SYDNEY WESTERN CITY PLANNING PANEL - ADDENDUM REPORT

Panel Number:	PPSSWC-27.
Application Number:	2019/710/1.
Local Government Area:	Camden.
Development:	Demolition of existing structures and construction of a place of public worship and an associated hall and car park, landscaping and associated works.
Capital Investment Value:	\$23.95 million.
Site Address(es):	320 Dwyer Road, Leppington.
Applicant:	Holy Apostolic Catholic Assyrian Church of the East Property Trust c/o PMDL Architecture and Design.
Owner(s):	Holy Apostolic Catholic Assyrian Church of the East Property Trust.
Date of Lodgement:	9 September 2019.
Number of Submissions:	23 (15 objecting to the development, seven supporting the development, and one raising matters for consideration).
Number of Unique Objections:	15 (from nine objectors).
Classification:	Regionally significant and integrated development.
Recommendation:	Approve with conditions.
Regional Development Criteria (Schedule 7 of State Environmental Planning Policy (State and Regional Development) 2011):	Community facility with a capital investment value >\$5 million.

The purpose of this addendum report is to seek the Sydney Western City Planning Panel's (t

Northern Boundary Elevation Comparison

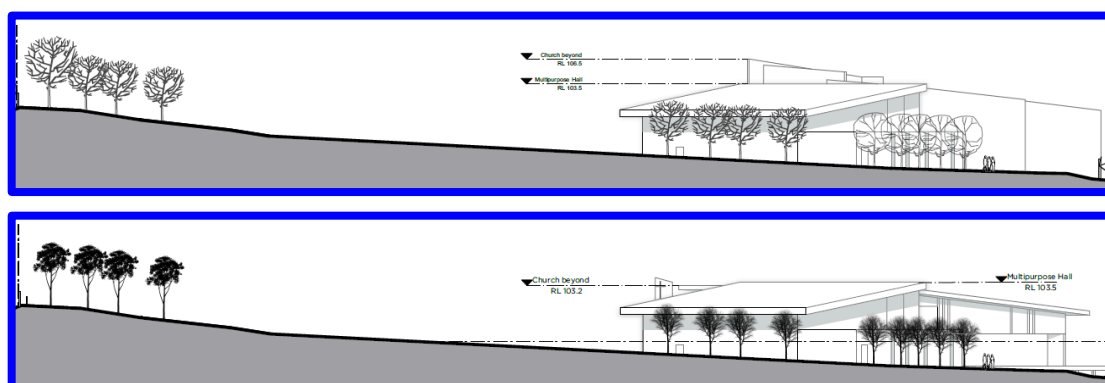
The height of the proposed church has been reduced, while the hall has remained largely unchanged. The church has been reduced in height from a maximum height of 11.25m to 8.95m (above the existing ground level), with the highest point of the roof below that of the proposed hall (RL 103.2 and 103.5 AHD respectively).

The church is also proposed to include an “*off-form concrete free-standing vertical element*” to a height of approximately RL 104. This will be approximately 7.5m above existing ground level (RL 96.5) and will be visible from the north, south and east. It is not anticipated that this element of the proposal will have adverse visual impacts.

Western Boundary Elevation Comparison

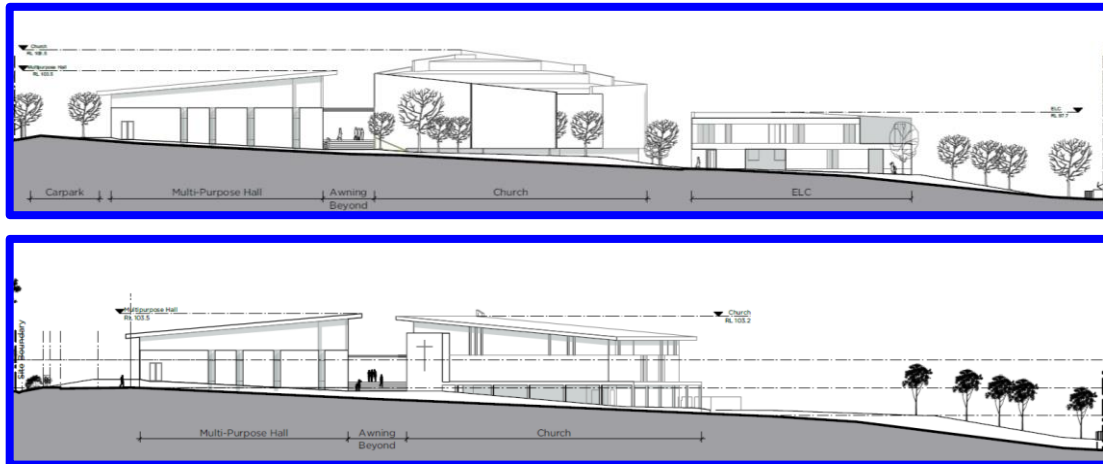
A comparison of the boundary elevations of the previous design and amended proposal is provided below.

Overall, the visual bulk of the church has been notably reduced, despite the increase in floor area.

Eastern Boundary Elevation Comparison

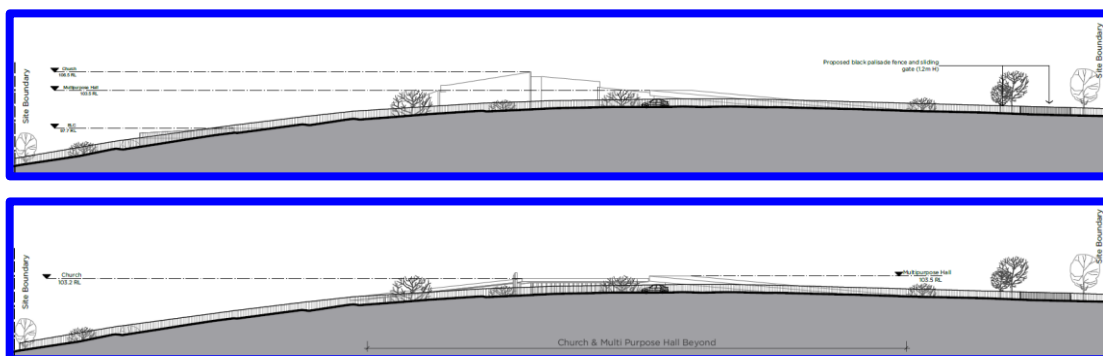
Note: Does not account for perspective and topography, with the Church having a front setback of 53m compared to the child care centre that had a front setback of 20m.

Architectural Plan Sections Extract

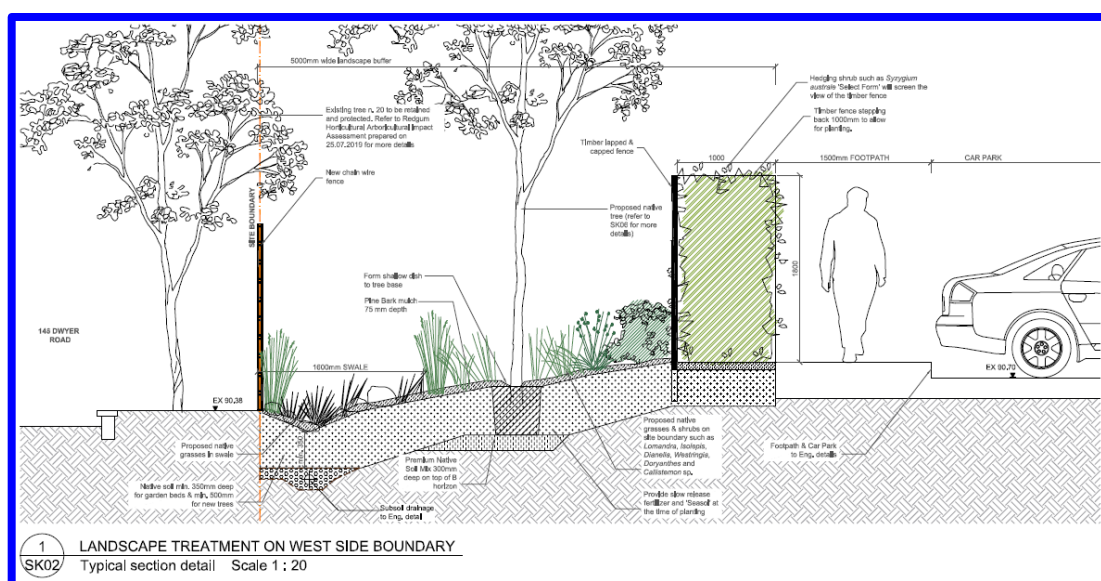
The proposal has been amended such that the retaining walls have been removed from the boundaries.

Per the extract of the boundary cross sections provided below (from sheets DA302 and DA303 of the amended architectural plans) a 1.8 metre high chain wire fence is proposed on the northern and western boundaries, with a 125mm-deep grassed drainage swale alongside it. Behind the drainage swale, a landscaped batter is proposed to a maximum grade of 1:6, with retaining walls and an acoustic barrier proposed at the top of the batter.

Rickard Road Preferred Route Option 2014

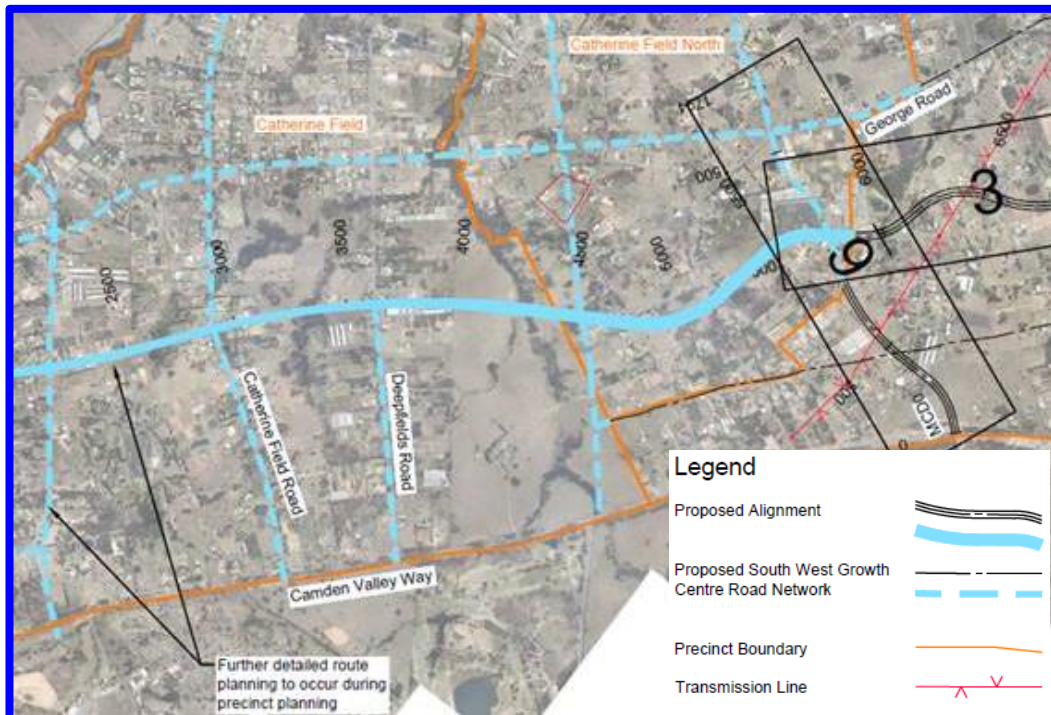
Concern was raised by a neighbour regarding the impact of the proposal on an indicative road location that is shown in the '*Rickard Road Strategic Route Study – Preferred Route Option Report*' prepared by ARUP on behalf of the then Department of Planning and Infrastructure and dated 9 January 2014.

The Design Plans in Appendix A of the Report (p. 60, extract below) show a proposed road that extends from Raby Road to intersect with the proposed Rickard Road extension. This indicative road then continues through the site (bordered in red), to the indicative George Road extension and beyond.

While it is noted that the proposed use may be a sensitive receiver in terms of acoustic amenity, and that this may have an impact on the design of future roads, no road corridor conservation process has been undertaken by Transport for NSW for the proposed Rickard Road extension, particularly for the section within Catherine Field North Precinct. Additionally, the application was referred to Transport for NSW in accordance with the provisions of State Environmental Planning Policy (Infrastructure) 2007, and no comments were provided with regard to the Raby Road connection.

As such it is not considered that the proposal will hinder the orderly and co-ordinated provision of infrastructure that is planned for the growth centre.

Rickard Road Preferred Route Option 2020

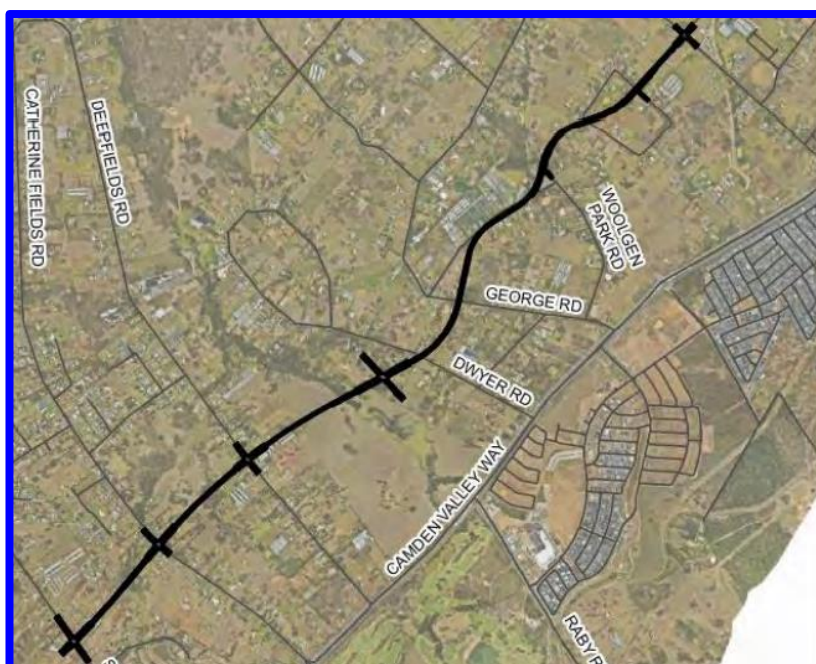
A further report, titled the '*Rickard Road Strategic Route Assessment – Preferred Route Option Report*' was prepared by ARUP on behalf of Transport for NSW following community consultation in July 2020, and is dated 7 September 2020. The preferred route identified in this report is more detailed than that identified in the 2014 Report and also includes an intersection to the south-east of the subject site to cater to a Raby Road connection. It is noted that a section of the main Rickard Road alignment between the proposed Raby Road and Catherine Fields Road will be raised above the existing terrain via a bridge, approximately 9 metres above the existing ground level.
